August 25, 2018

Version 2

A/C Does Not Blow Cold Air and Condenser Leaks at Receiver Dryer Cap

Supersedes 18-080, dated August 22, 2018, to revise the information highlighted in yellow

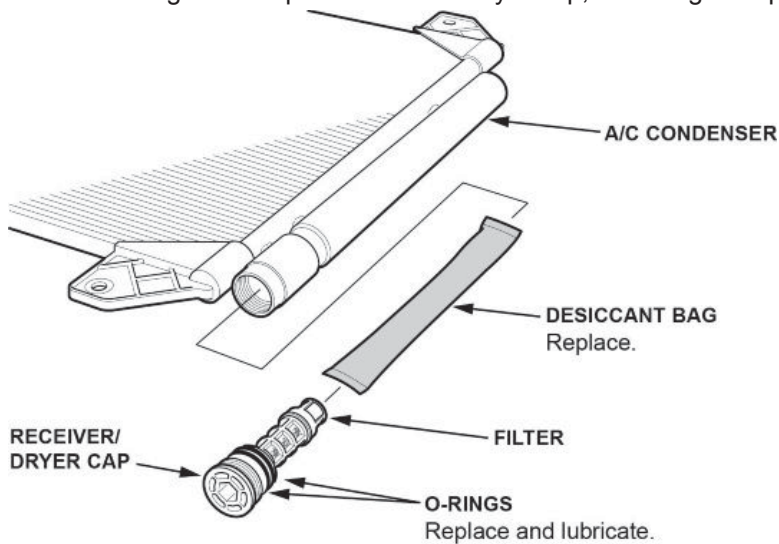
Check if the A/C is blowing cold air and there is staining around the receiver dryer cap on the condenser.

- If the A/C is not blowing cold air and there is staining around the receiver dryer cap on the condenser, go to REPAIR PROCEDURE.
- If the A/C is not blowing cold air and there is no staining around the receiver dryer cap, continue with normal system troubleshooting.
